# Diamond Dorado Retail Center Project Final Environmental Impact Report

State Clearinghouse No. 2008012004

El Dorado County ■ July 23, 2012

**FINAL**  
**Environmental Impact Report**  
**Diamond Dorado Retail Center Project**  
**Diamond Springs, El Dorado County, California**

**DIAMOND DORADO RETAIL CENTER**  
**PRE-DEVELOPMENT SHED MAP**  
 DIAMOND SPRINGS, CALIFORNIA  
 SCALE: 1"=100' MARCH, 2008

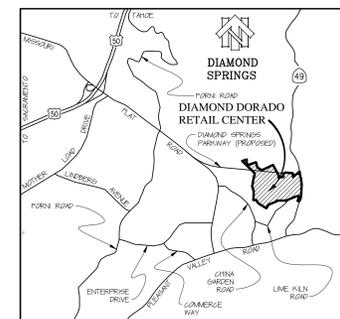
- A review of the Post Development Shed map indicates that runoff will be captured on site and conveyed through a proposed storm drain across SR-49. Please provide detailed design with back-up calculations for the proposed storm drain across SR-49. The culvert should be designed to ensure that the highway will not be overtopped during a design 25-year event and no adverse downstream impacts would be expected.

- No drainage plans, drawings, calculations, or hydrologic/hydraulic reports were received with the application. As the proposed project site is located immediately adjacent to State Route 49, the development of this site will increase impervious surface area through the construction of roads, driveways, parking areas and structures with a corresponding increase in surface water (storm water) runoff. Any runoff increase introduced by the construction of the project must be quantified and mitigated to avoid potential adverse hydrologic and/or hydraulic impacts down stream of the proposed project site. To adequately evaluate these potential impacts upon the State's right of way, and drainage facilities, a detailed drainage plan with "pre-construction" and "post-construction" hydraulic calculations should be supplied for our review. Please request these calculations and send them to Mr. Gurdeep Bhattal for review prior to final project approval. Mr. Bhattal can be reached at (530) 741-4056. 15

The developer is required to submit a Drainage Study with the improvement plans. The Conditions of Approval will be modified to include approval by Caltrans for the analysis and design within the SR-49 corridor.

The Preliminary Drainage Report's watershed maps have been appended to Appendix I of the Draft EIR; the maps are included at the end of this section.
